Product Change Notification

Product Change Notification: P-15-011848

PCN Date: 14-JUL-15

1.25 A-F CONN. TAB ASSEMBLY TOP ENTRY TYPE (917361)

Tray modification

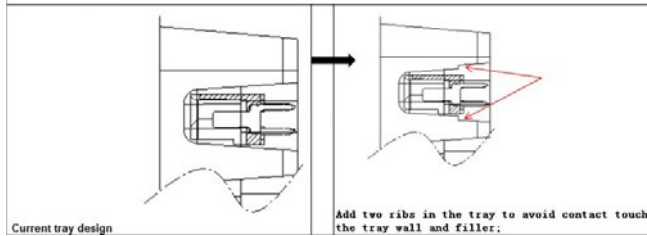
Packaging tray modified- two ribs added in the tray to avoid contact of pins with the tray wall. Quantity per tray reduced by 18 pcs. Shipping quantity changed from 14 trays to 12 trays per carton.

1.change tray design:

Customer Request.To avoid damage and bending of connector pins.
